PATENT
Serial No. 10/524,570

Amendment in Reply to Non-Final Office Action of July 10, 2006
Confirmation No. 8445

Amendments to the Drawings:

FIG. 1

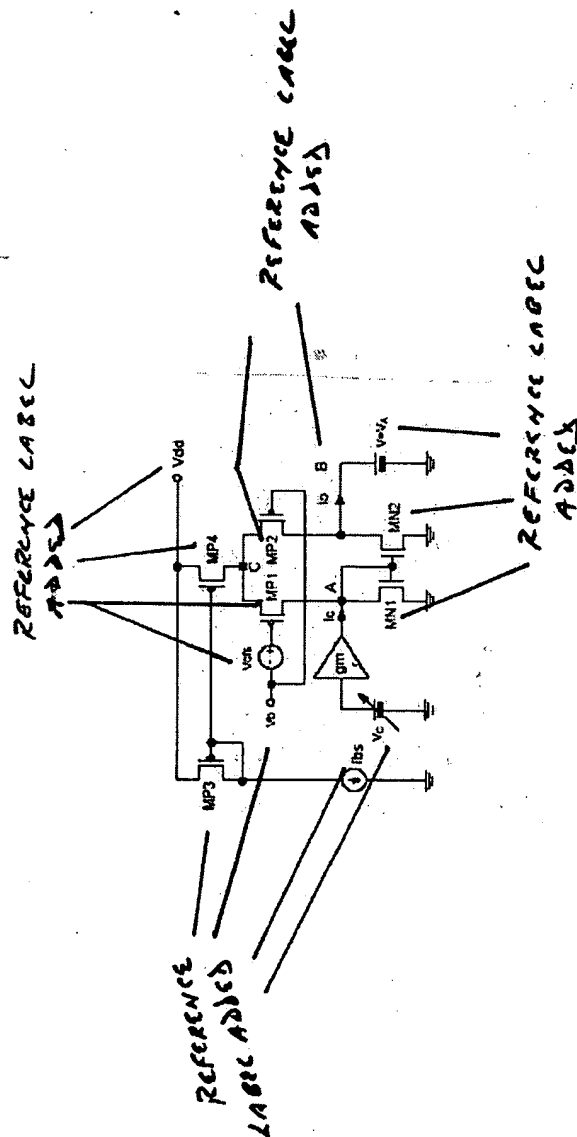
The attached drawing sheets include changes to FIGS. 1, 2 and 4, respectively. These sheets replace the original drawing sheets including FIGS. 1, 2 and 4. In each of FIGS. 1, 2 and 4, reference signs have been added as mentioned in the detailed description.

In the Office Action, the drawings were objected to for failing to include reference labels as specified in the detailed description. Proposed new drawings, Figures 1, 2 and 4, are provided in response to the objection. Applicants respectfully request withdrawal of the drawings objection and approval of the enclosed proposed drawing changes.
